NUMBER: 07-002-14

Coolant Weepage At EGR Hose

2011 - ****2014**** LX Chrysler 300 (International Only)

Fig. 1 EGR

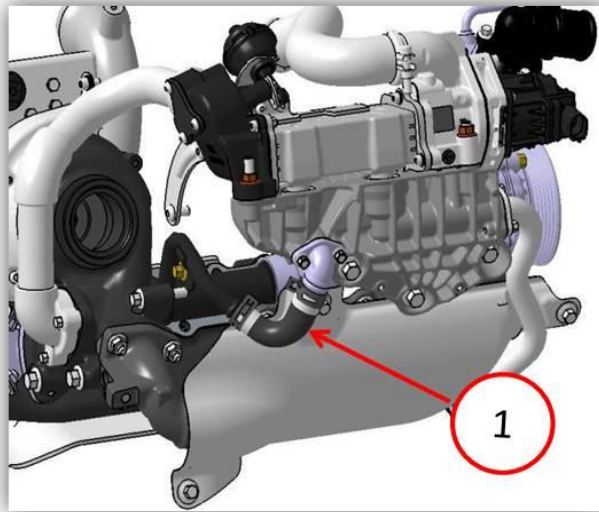
The EGR hose may weep coolant.

2. Lower the belly pan splash shield.
3. Lower the rear transmission splash shield.
4. Replace the EGR coolant hose.
